2. Hidden Hills Tract G5 Replat; KPB File 2023-092

HIDDEN HILLS TRACT G5 REPLAT

**ITEM #2 - PRELIMINARY PLAT
HIDDEN HILLS TRACT G5 REPLAT**

KPB File No.	2023-092
Plat Committee Meeting:	September 11, 2023
Applicant / Owner:	Allen and Linda Engebretsen of Homer, Alaska
Surveyor:	Stephen Smith / Geovera, LLC
General Location:	Anchor Point / Anchor Point APC

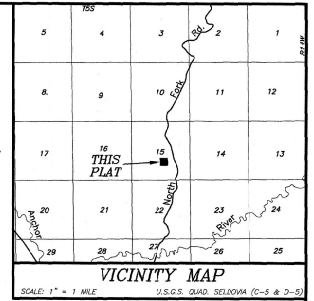
Staff recommendation: Please show less area in the vicinity map to give a closer view of where the subdivision is located.

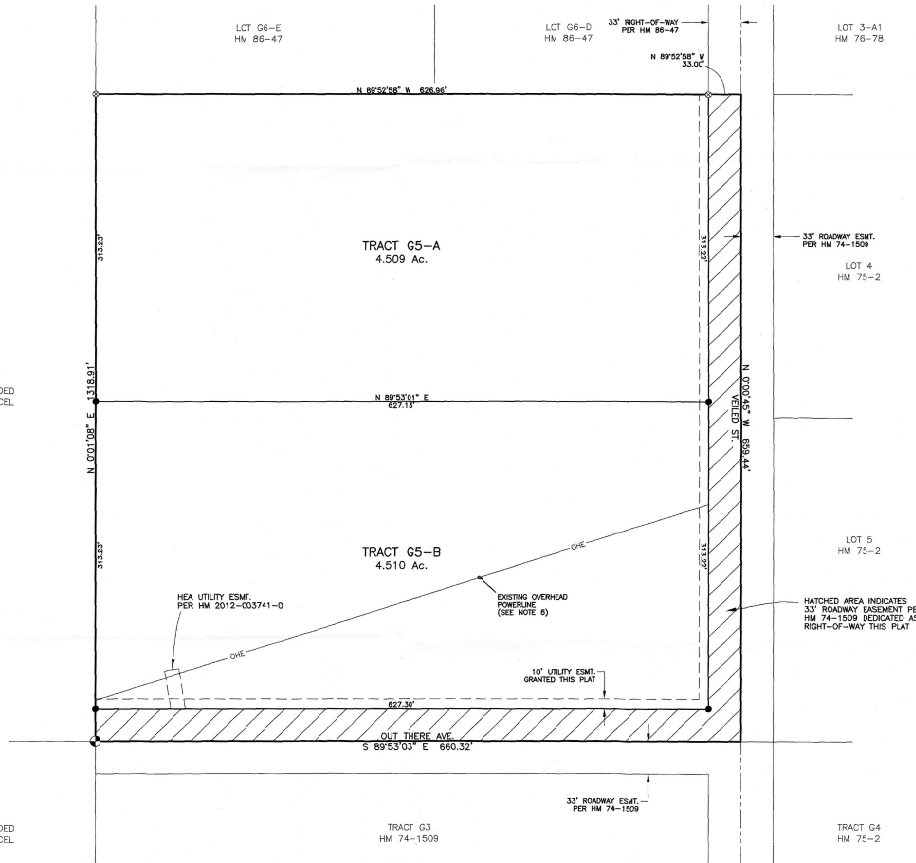
Staff recommendation: Update the KPB file number to 2023-092. Correct the aliquot description and Township and Section.

Change the acres to 9.991 to include the right-of-way area. As they were easements before.

Staff recommendation: Please correct the plat number for G4 located to the southeast. The plat 75-2 is the vacated right-of-way included in this parcel.

Include the filing information of the easement in plat note #6.

Staff recommendation: Depict the building setback along both dedications.

- West line of the plat needs correct distance listed on the primary drawing.
- North line should give an overall distance for the line on the primary drawing.

- Add Certificate of Acceptance
- Add date of September 11, 2023 to Plat Approval certification
